EARLY DESIGN GUIDANCE

9201 Delridge Way SW
Seattle, WA

SDCI PROJECT NO.:
3029353

MEETING DATE:
12/28/17

VICINITY MAP KEY

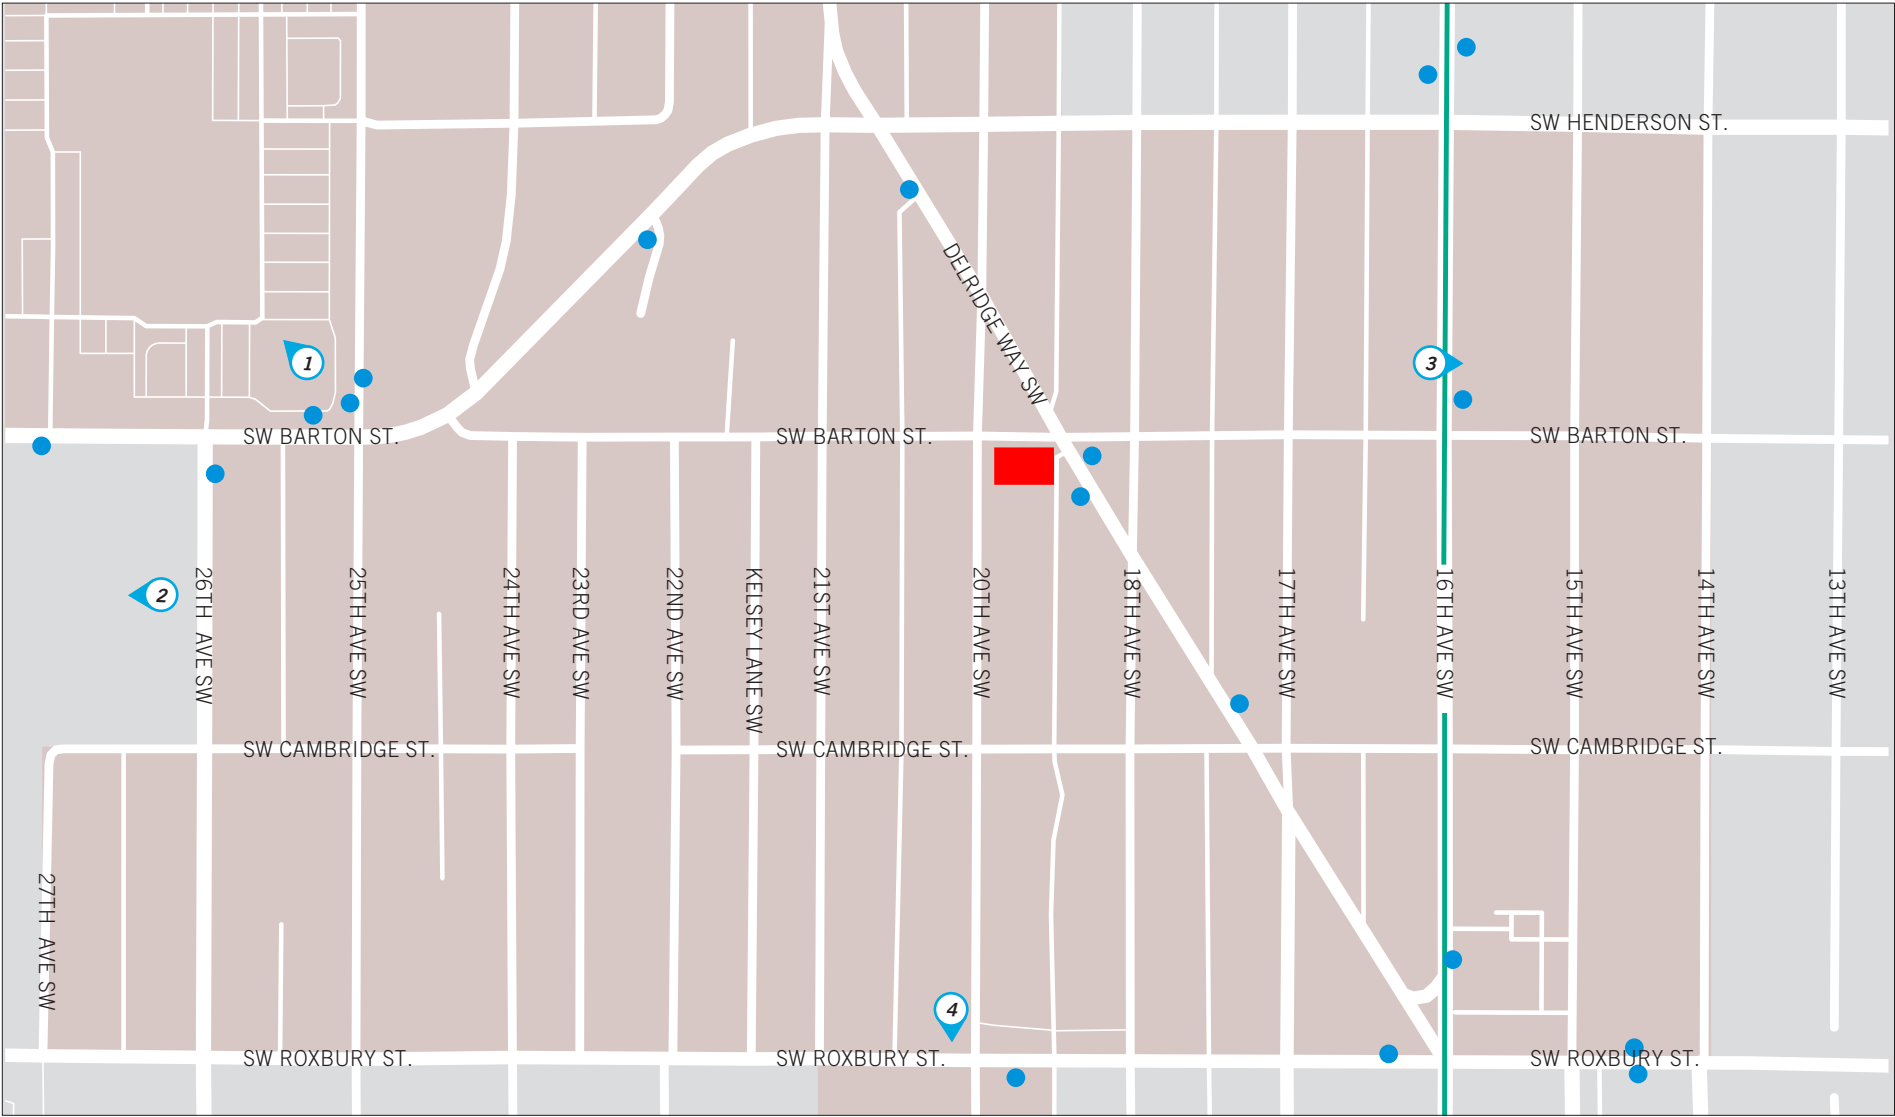
Describe a bit about why these four sites are selected. What is the significance? Is the project taking design cues from these sites?

Is it likely routes (pedestrian and/or vehicular) will be to/from these sites?

This photo is difficult to read in the printed version. Try lightening.

1 SW BARTON ST LOOKING NORTH

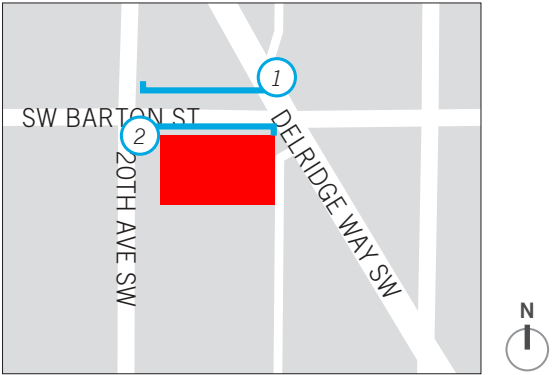
I encourage you to extend this montage a bit to include this structure.

Again, many of the photos are difficult to read in the printed packet. Try lightening.

3 20TH AVE SW LOOKING EAST

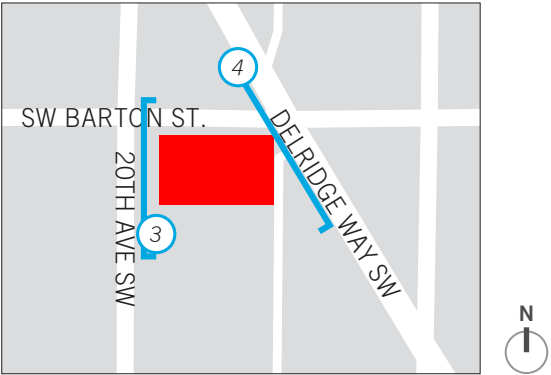
Is this the alley? Adding labels to these montages may help in understanding the site.

CONCEPT DIAGRAMS

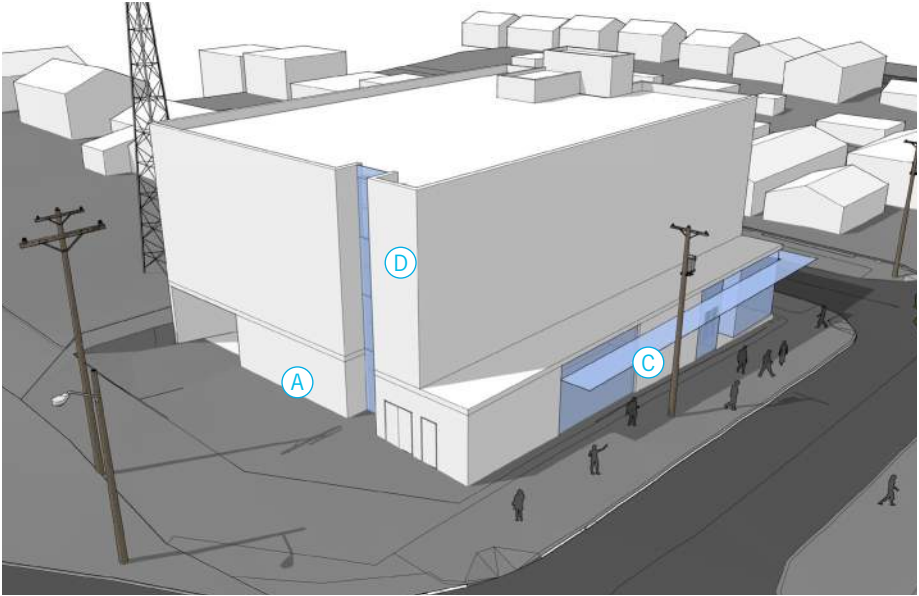
add street names

what type of materials are you considering?

DESIGN ANALYSIS

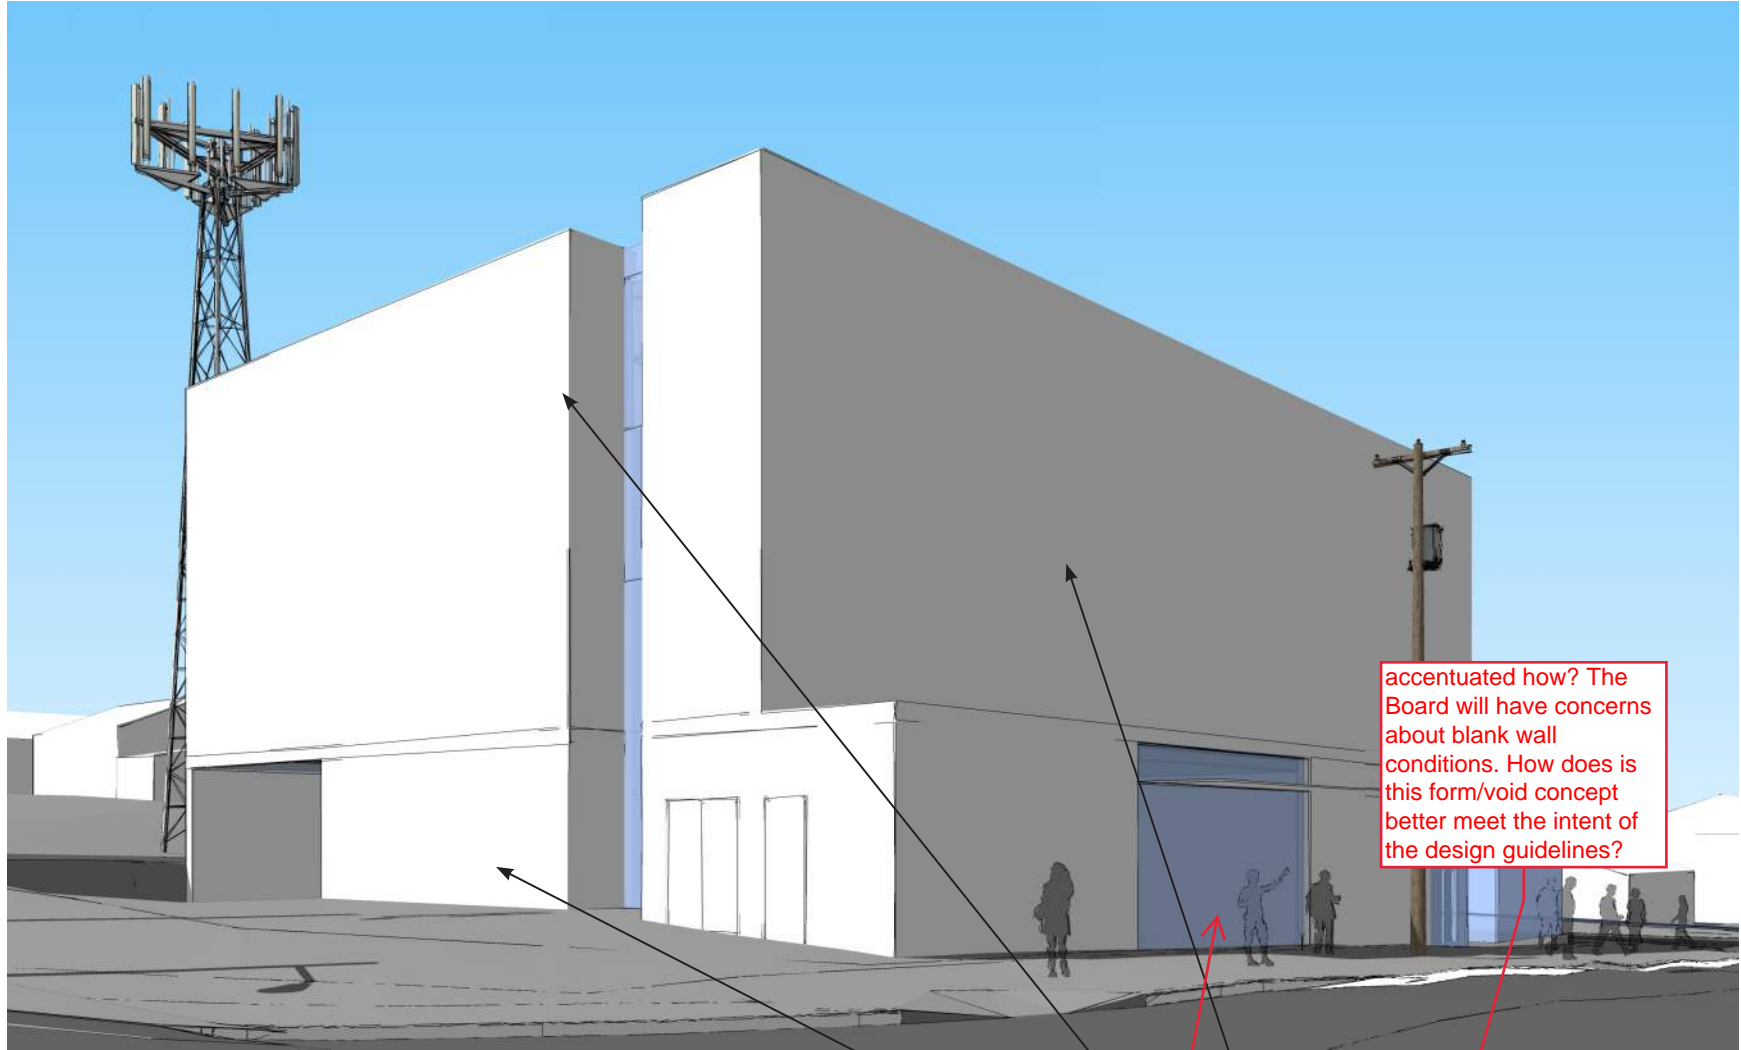
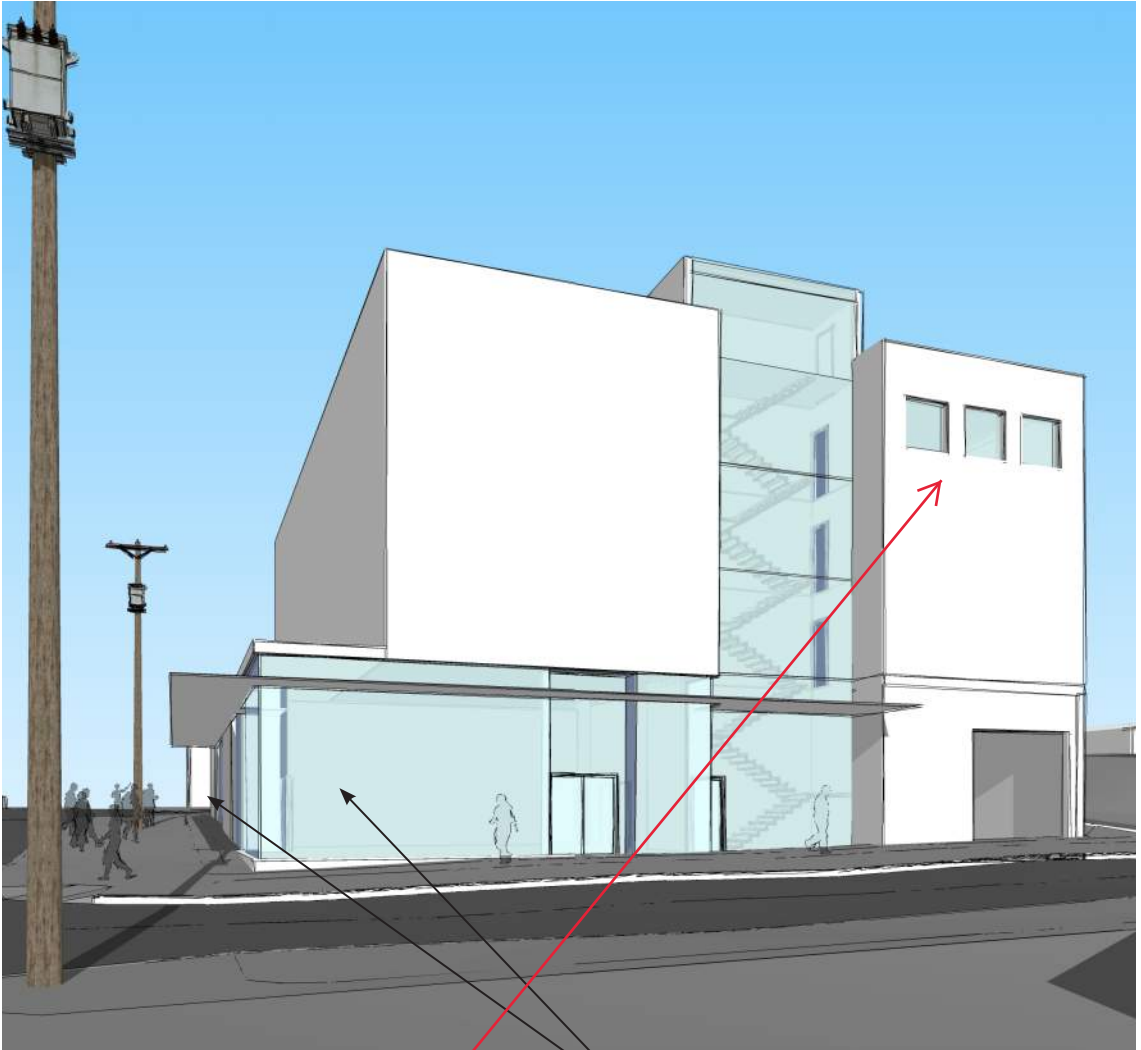
accentuated how? The Board will have concerns about blank wall conditions. How does is this form/void concept better meet the intent of the design guidelines?

is this glazing proposed at the parking?

appears the caretaker unit is over here, facing 20th. does is this comment still relevant?

8.0 OPTION 1 | FLOOR PLANS

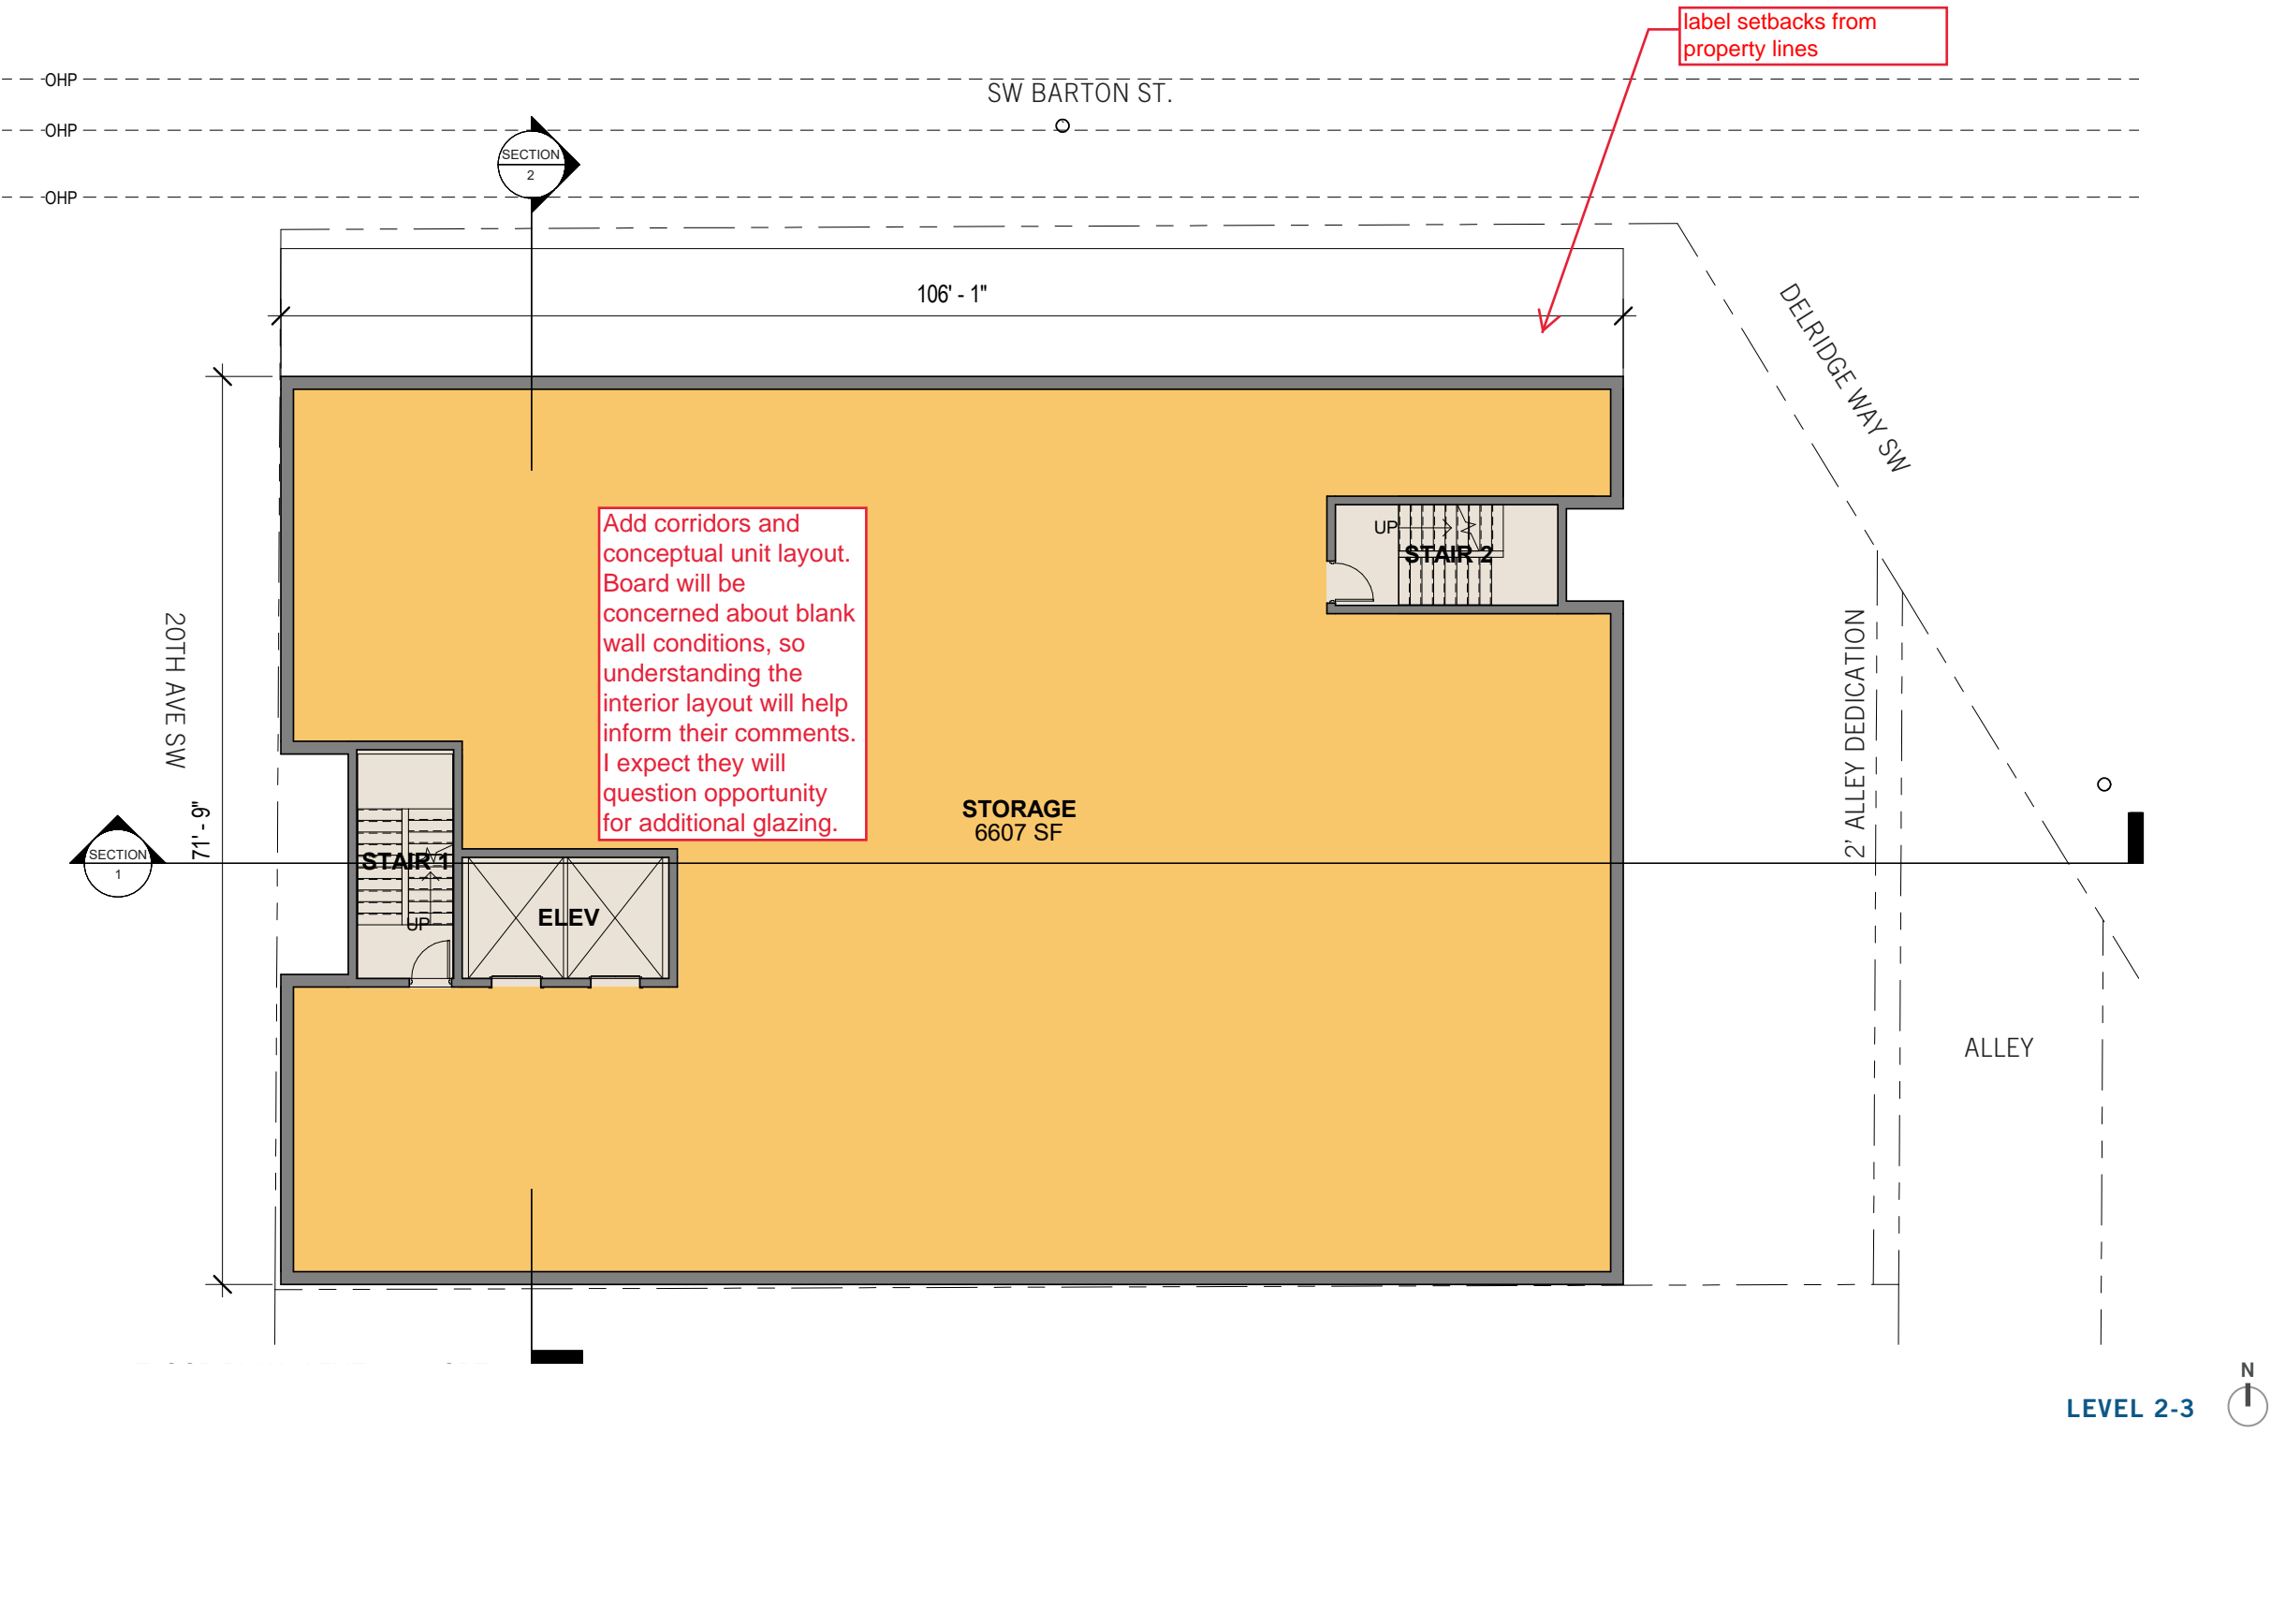
All comments apply to the floor plans for each option.

CONCEPT DIAGRAMS

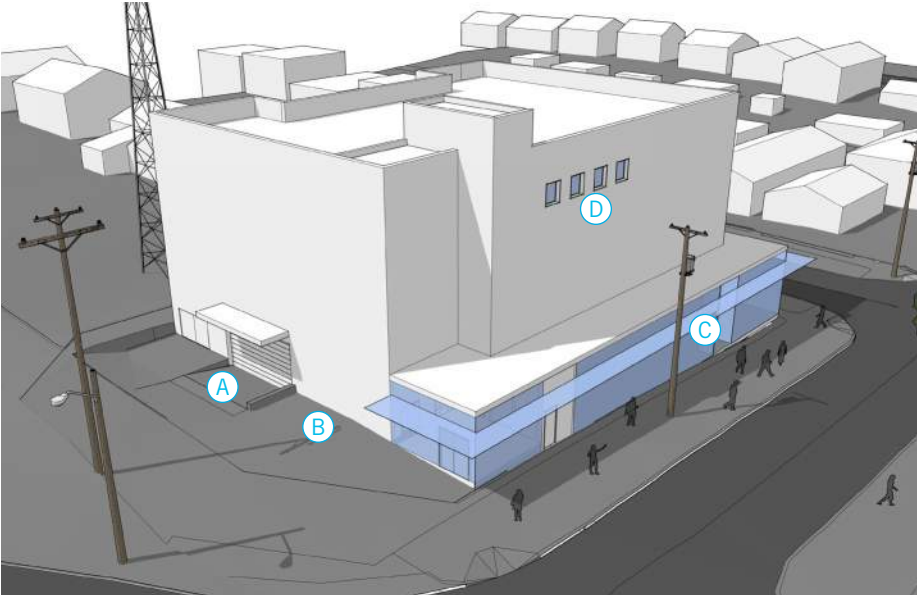
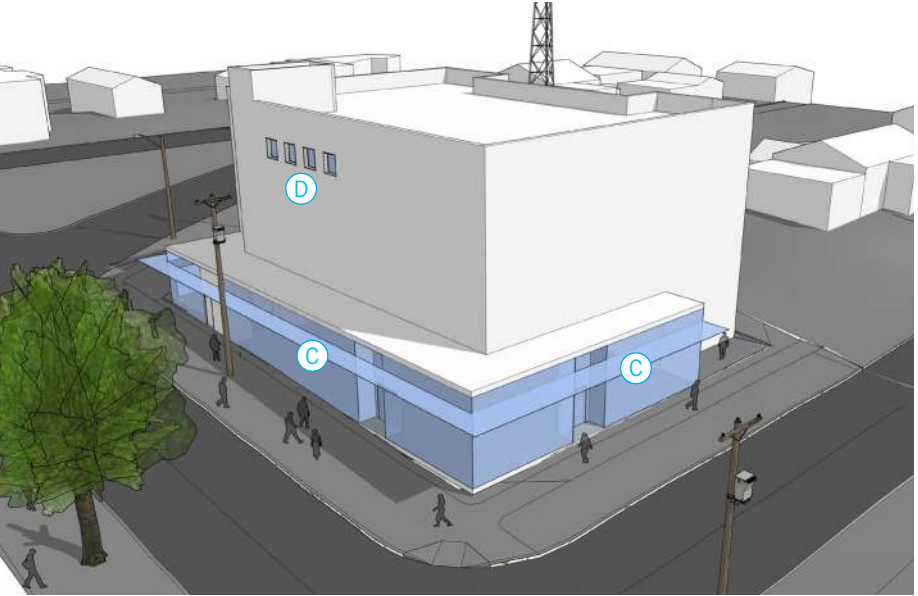
as noted on page 13, it appears the same architectural concept is applied to options 1, 2, and 3.
Are they different? The Board expects to see three different, viable alternatives. We need to highlight the differences/bring forward three concepts.
